PRODUCT/PROCESS CHANGE NOTICE (PCN)

PCN #: A1401-01 Product Affected: 5.0mm x 7.0mm CDIP-10 Date Effective: 7-Jun-2014	DATE: 7-Mar-2014	MEANS OF DISTINGUISHING CHANGED DEVICES: <input checked="" type="checkbox"/> Product Mark <input type="checkbox"/> Back Mark Change in capacitor is traceable through assembly lot code. <input type="checkbox"/> Date Code <input type="checkbox"/> Other
---	-------------------------	---

ATTACHMENT I - PCN # : A1401-01

PCN Type: Alternate Capacitor
Data Sheet Change: None
No change in moisture sensitivity level (MSL)

Detail Of Change:

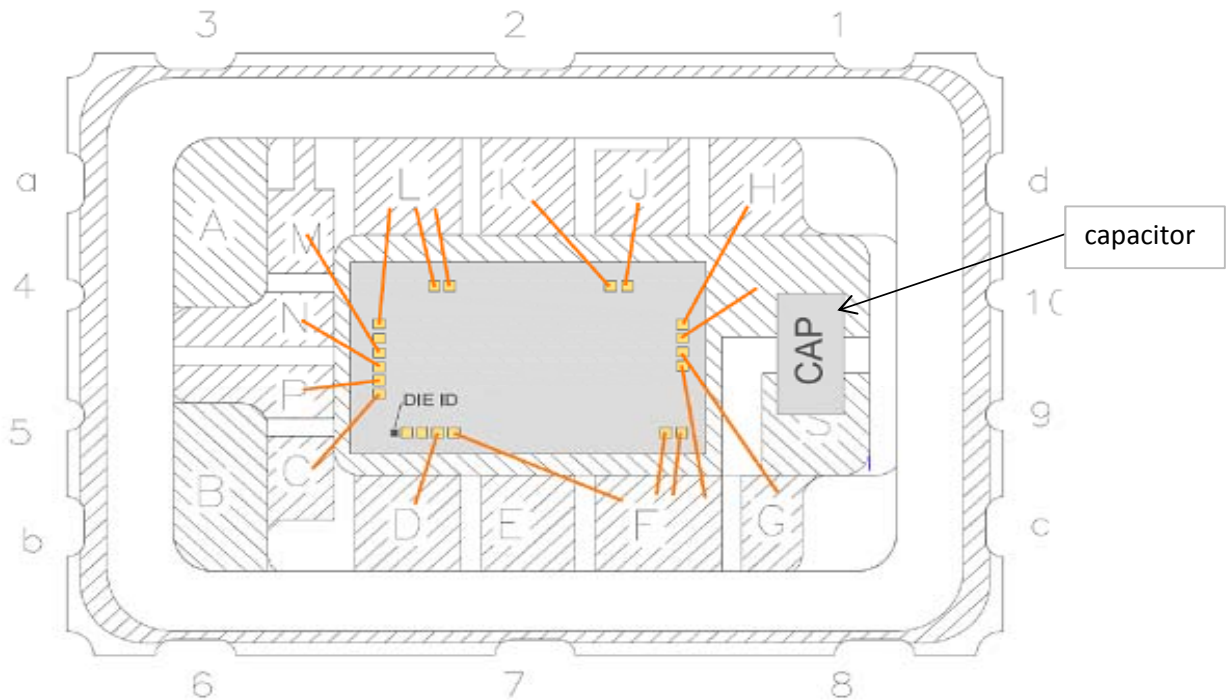
This notification is to advise our customers that IDT has qualified an alternate capacitor used internal to the package of 5.0mm x 7.0mm CDIP-10. Refer to below illustration.

This alternate capacitor was designed with these key features:

1. End cap shape to optimize mounting with conductive cement.
2. Reduce the use of gold.
3. Exceptionally high reliability for the auto industry application.
